MODIFICATIONS TO

SEDIMENT CONTROL (EPSC) PLAN

MONTGOMERY 1448(27)

EPSC NARRATIVE AMENDED

SITE SPECIFIC EPSC PLAN
MONTGOMERY BHO 1448(27)

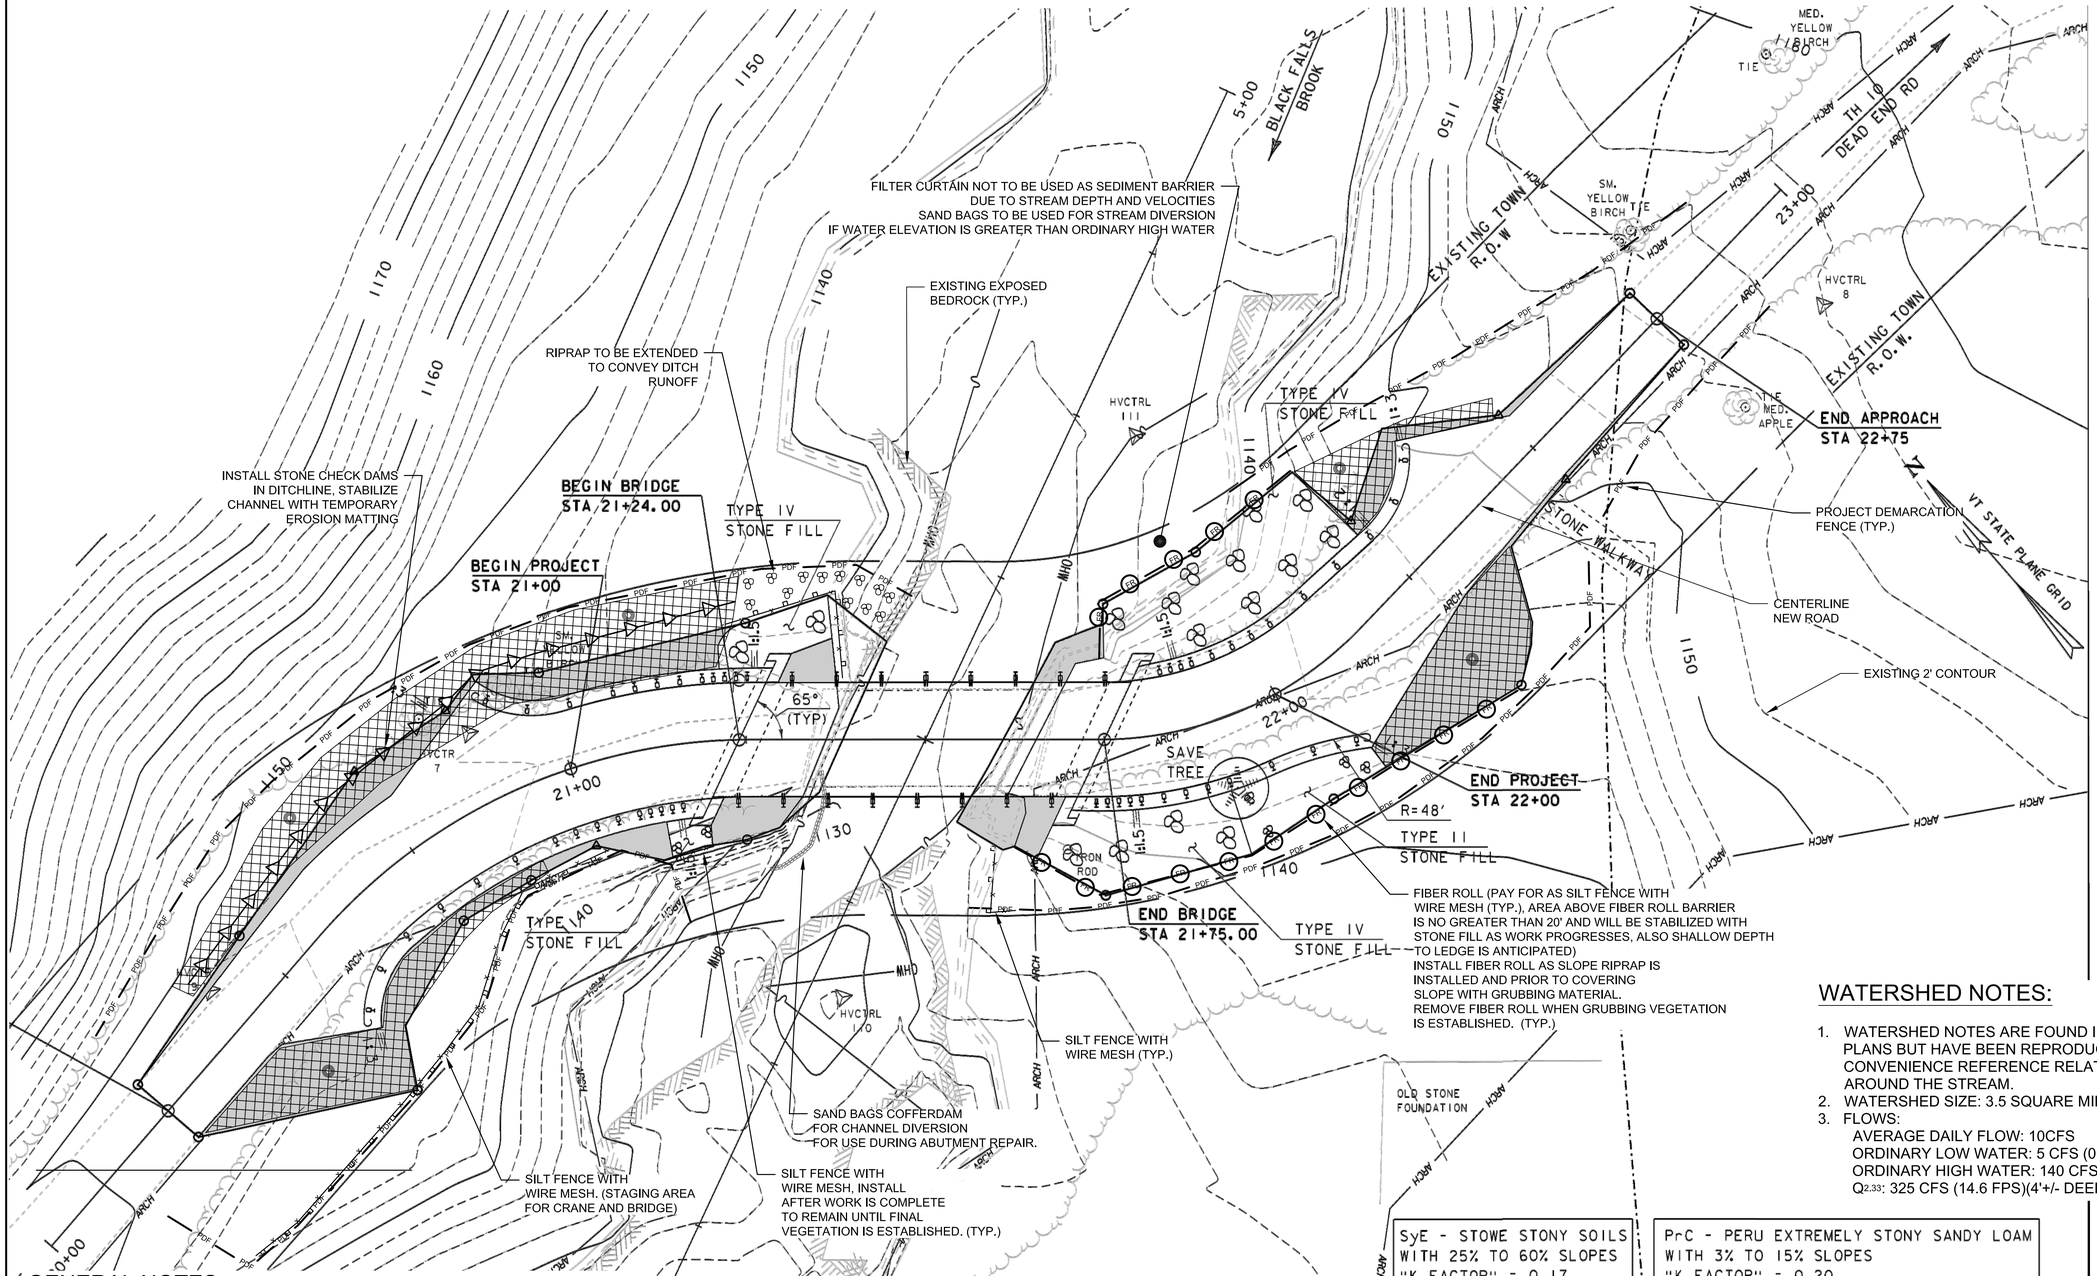
Site disturbance will include approximately 0.25 acres which includes 200' of 12' wide roadway.

No stabilized entrances will be used. The road must remain open for the project except for a consecutive closing for 60 hours to set the new bridge. All excavation and soil placement will be performed from the existing road. No off-road tracking will be present.

Sediment barriers will include silt fence with wire mesh, stone check dams and erosion logs. Runoff flow lengths are generally 20' or less. The intent of the erosion logs is for installation after the stone fill is installed and covered with grubbings. Off-site flows will enter the new ditch line along station 20+25 to 21+25 which will require temporary sediment barriers until vegetation is established.

Slopes around the guardrail ends are shown as 1:3 and erosion matting will be installed. Work will be within 50' of the stream.
